**Staff Report  
BOA-23921**

1546 South Harvard Avenue  
Tract Size: ±0.14 acres

<b>Project Name:</b>	16th & Harvard - ADU
<b>Date:</b>	7.18.2025
<b>Response By:</b>	Cody Rogers cDesign, LLC. PO Box 576 Mounds, OK 74047 918.809.6813 cdesignhomes@gmail.com

<b>Plan Corrections Summary:</b>	BLDR-210056-2025 (1546 S HARVARD AVE E Tulsa, OK 74112) Markup Summary #1
<b>Project Name:</b>	16th & Harvard - ADU
<b>Application Number:</b>	BLDR-210056-2025
<b>Plans Examiner:</b> Architectural	George Goza City of Tulsa - Development Services 175 East 2nd Street, Suite 450 Tulsa, OK 74103 918.576.5405 ggoza@cityoftulsa.org
<b>Plans Examiner:</b> WSD	James Henley City of Tulsa - Development Services 175 East 2nd Street, Suite 450 Tulsa, OK 74103 918.596.7344 jameshenley@cityoftulsa.org
<b>Plans Examiner:</b> Zoning	Danny Whiteman City of Tulsa - Development Services 175 East 2nd Street, Suite 450 Tulsa, OK 74103 918.596.9664 dwhiteman@cityoftulsa.org
<b>Corrections Summary:</b> Received Date	4.18.2025
<b>Corrections Summary:</b> Response Date	5.6.2025
<b>Response By:</b>	Cody Rogers cDesign, LLC. PO Box 576 Mounds, OK 74047 918.809.6813 cdesignhomes@gmail.com

**SHEET NUMBER**  
 SP.01  
 Site Plan

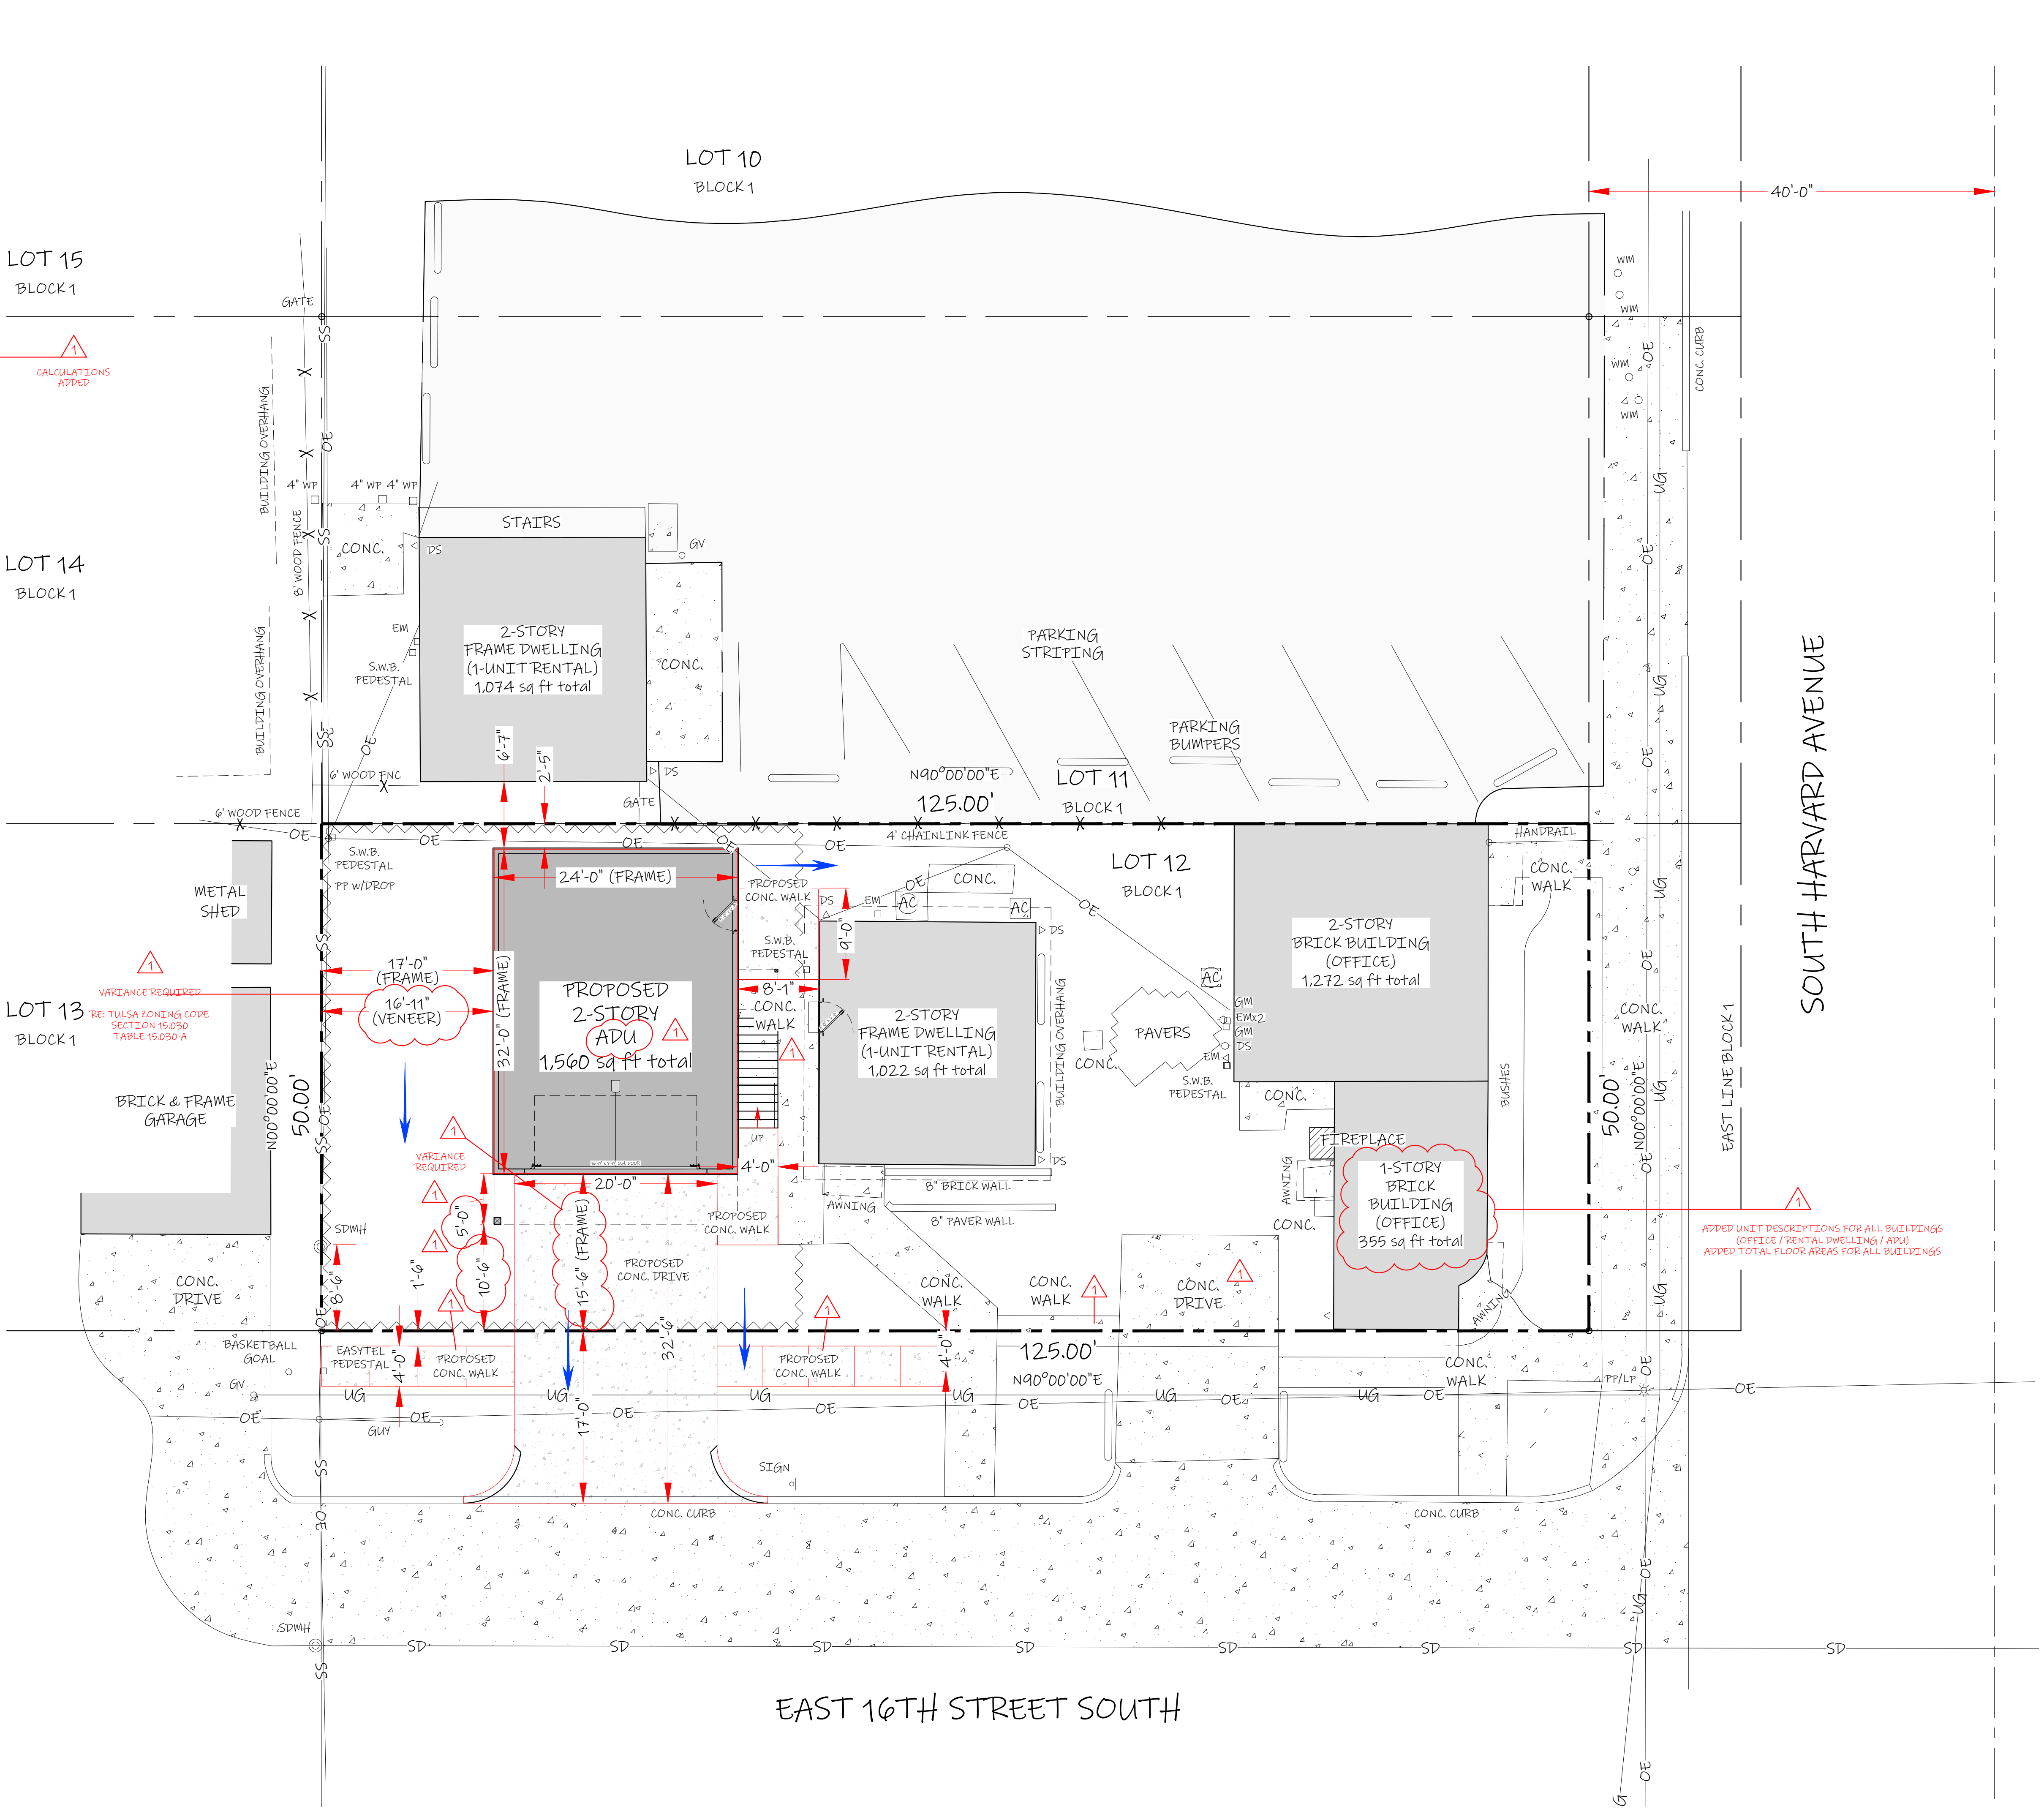
*Revise site plan to show a measurement from the centerline of the 8" sewer main to the Westernmost edge of the proposed structure. Minimum setback from the center of the line, based on line depth, is 10ft.*

*The Site Plan does not show sidewalks. Sidewalks are required on curb and gutter streets pursuant to: Title 35 Section 602 B – Tulsa City Ordinance  
[https://library.municode.com/ok/tulsa/codes/code\\_of\\_ordinances?nodeId=COOR\\_TIT35IND\\_CH6FARI-WAC](https://library.municode.com/ok/tulsa/codes/code_of_ordinances?nodeId=COOR_TIT35IND_CH6FARI-WAC) Title 42 Section 70.080 B.2. 4 Sidewalks – Tulsa Zoning Code  
<http://tulsaplanning.org/programs/zoning/zoning-codes/TMAPC> Subdivision and Development Regulations Section 5-070 Sidewalks  
<http://tulsaplanning.org/plans/Tulsa-Subdivision-Development-Regulations.pdf>  
Revise site plan to show public sidewalks. Sidewalks must be shown on the site plan for permit approval, even if you intend to pay the fee-in-lieu of sidewalks at a later date.  
Corner lot note: Sidewalks must be installed from the West property line to the East property line, then continue around the corner to the North property line.*

*On the new permit application, revise the plans to show that any garage doors facing 16th St. will be set back at least 20' from the south property line.*

*The lot to the west of this lot is RS zoned. According to the table the base setback required is 10' from an RS zoned lot. According to the footnote, 2' of additional setback is required for each foot of building height above 15'. The proposed building height is 23' 11" which is 8' 11" above 15'. Therefore, 17' 10" needs to be added to the base setback of 10'. In summary, this building as proposed requires a 27' 10" setback from the west property line. Please revise plans accordingly.*

*According to the table in this section, a 10' street setback is required. Please revise the plans so that no part of the proposed building, including the front deck, is located closer than 10' to the south property line.*

*According to the table in this section, a maximum floor area ratio of 0.50 is allowed. With the proposed and existing buildings, the floor area ratio being proposed is 0.67. This is the area of all floors of all buildings, divided by the area of the lot. See Section 90.050. Please revise the plans to reduce the proposed building floor area to no greater than 450 square feet, to achieve a maximum floor area ratio of 0.50.*

Refer to revised sheet SP.01 - Site Plan. The dimension to the centerline of the 8" sewer main to the Westernmost edge of the proposed structure has been added and exceeds the minimum requirement.

Refer to revised sheet SP.01 - Site Plan. The required sidewalks are now shown along the Southern property line with existing public sidewalks added and notated. There is one section of existing sidewalk that sits directly on the South property line. If an additional sidewalk is to be required in this section, please advise.

Refer to revised sheet SP.01 - Site Plan. The garage door facing 16th Street is now set back 15'-6".  
Variance / Administrative Adjustment Required

Refer to revised sheet SP.01 - Site Plan & revised sheet RP.01 - Roof Plan. The proposed building has been repositioned and now has a set back of 16'-11" from the lot to the West. The proposed building height of 23'-11" did not change. Variance Required

Refer to revised sheet SP.01 - Site Plan. The front deck has been reduced in size and repositioned to set back 10'-6" from the South property line.

Refer to revised sheet SP.01 - Site Plan. See also the added "Floor Area Calculations" found on SP.01. The proposed building floor area ratio of 0.67 did not change. Variance Required
